HISTORIC AND DESIGN REVIEW COMMISSION

August 2, 2023

HDRC CASE NO: 2023-282
ADDRESS: 2218 W GRAMERCY PLACE
LEGAL DESCRIPTION: NCB 6823 BLK LOT 4&5
ZONING: R-6, H
CITY COUNCIL DIST.: 7
DISTRICT: Monticello Park Historic District
APPLICANT: Cameron Smithdish | Smithdish Architecture
OWNER: Andrew & Kendall Cox
TYPE OF WORK: Column removal, front door replacement, shutter installation, and fenestration modifications
APPLICATION RECEIVED: July 10, 2023
60-DAY REVIEW: September 8, 2023
CASE MANAGER: Bryan Morales

PROPOSED FRONT DOOR - REFURBISH ANTIQUE COTTAGE STYLE WITH GLASS LITES.

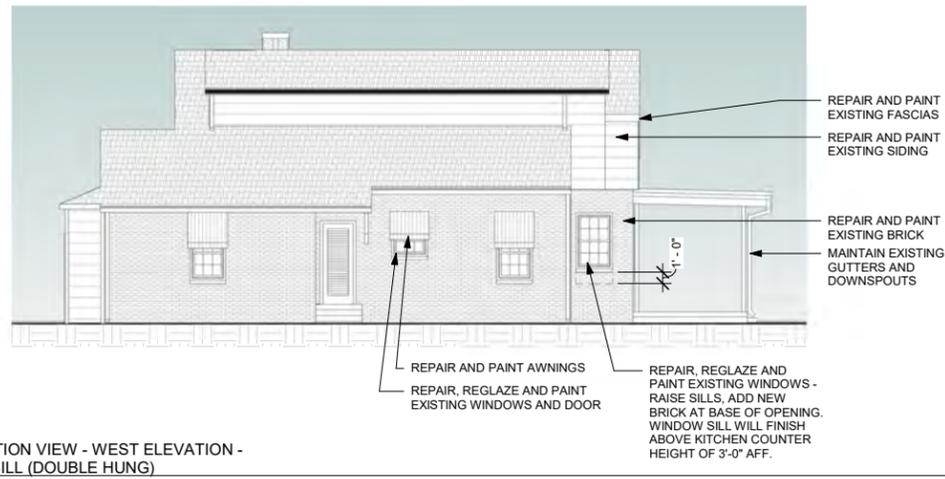
- c. FRONT DOOR REPLACEMENT – The applicant is requesting to remove the front door and replace it with a Craftsman style front door. Guidelines for Exterior Maintenance and Alterations 6.A.ii. states to preserve historic doors. In addition, Exterior Maintenance and Alterations 6.B.i. states to replace doors in-kind when possible and when in-kind replacement is not feasible, to ensure features match the size, material, and profile of the historic element. Staff finds the proposed Craftsman style door does not conform to the colonial revival style of the structure and does not conform to guidelines.

- i. That the applicant install operational wood shutters on the second floor, front façade.
- ii. That the applicant install a wood, Classical Revival front door and submit the final product information to staff for review.
- iii. That the applicant reuse the historic wood windows for fenestration modifications.
- iv. That the applicant use brick to match existing brick in dimension, texture, and color.

6 RENOVATION VIEW - WEST ELEVATION - RAISED SILL (DOUBLE HUNG)

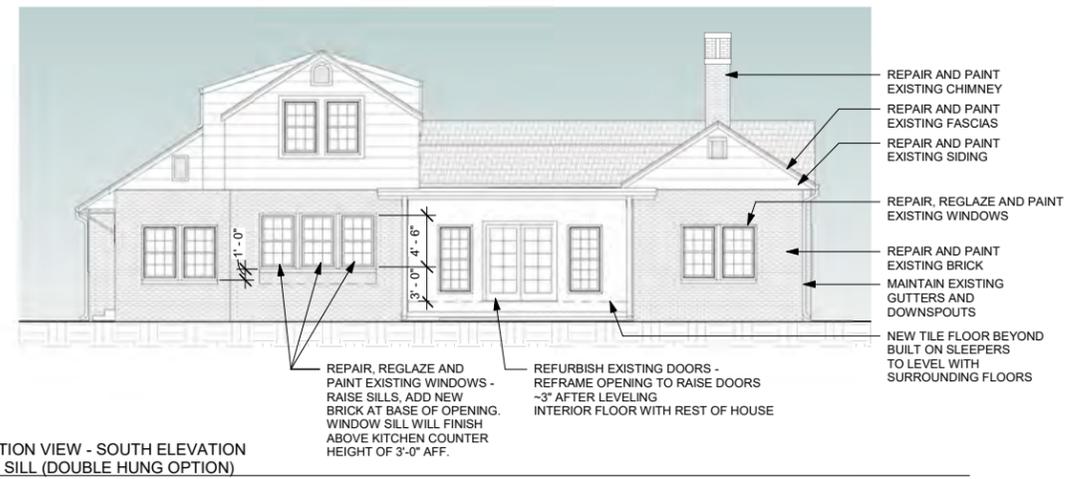
- e. FENESTRATION MODIFICATIONS (REAR DOOR) – The applicant is requesting to raise the two doors on the south elevation by three inches. Exterior Maintenance and Alterations 6.A.i. states to preserve existing window and door openings. The applicant’s proposed modifications maintain the general fenestration pattern of the rear façade. Staff finds the increase in height by approximately three inches is generally appropriate.
- f. FENESTRATION MODIFICATIONS (WINDOWS) – The applicant is requesting to raise three windows on the south elevation and one window on the west elevation by one foot. Exterior Maintenance and Alterations 6.A.i. states to preserve existing window and door openings. The applicant’s proposed modifications maintain the general fenestration pattern of the south and west façades. Staff finds the increase in height by approximately one foot is generally appropriate.

3 RENOVATION VIEW - NORTH (STREET) ELEVATION

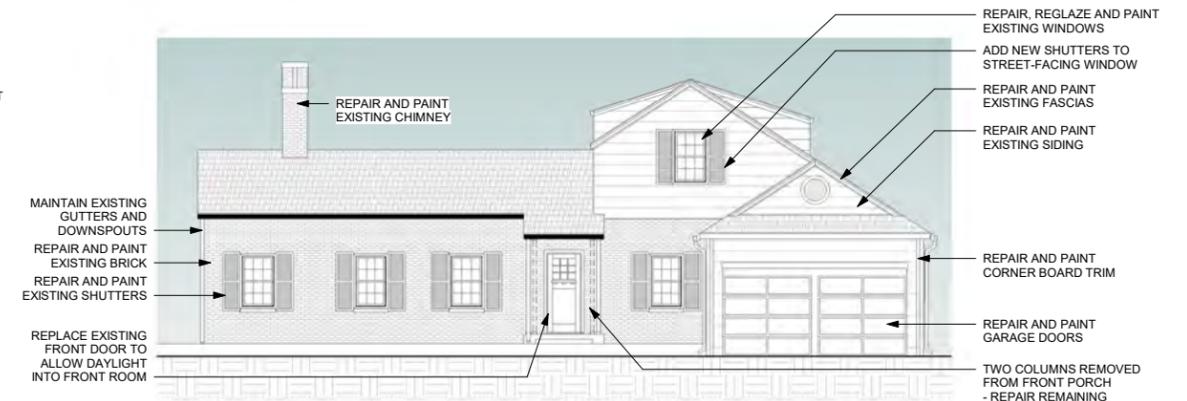
- b. COLUMN REMOVAL – The applicant is requesting to remove the two, inner front columns located on the front porch. The Historic Design Guidelines for Exterior Maintenance and Alterations 7.A.i. states to preserve porches, balconies, and porte-cocheres. The 1938 Sanborn map and modern satellite images confirm that the present location of the front porch is not original. Staff finds the removal of the two, inner columns at the front of the porch generally conforms to guidelines.

- d. SHUTTER INSTALLATION – The applicant is requesting to install shutters on the second-story window facing W Gramercy Place. Exterior Maintenance and Alterations 6.B.x. states to incorporate shutters only where they existed historically and where appropriate to the architectural style of the house. Additionally, shutters should match the height and width of the opening, be mounted to be operational or appear to be operational, and not be installed directly onto any historic wall material. Staff finds the installation of shutters that do not match the

height and width of the window opening and are not operational or appear to be operational does not conform to guidelines.
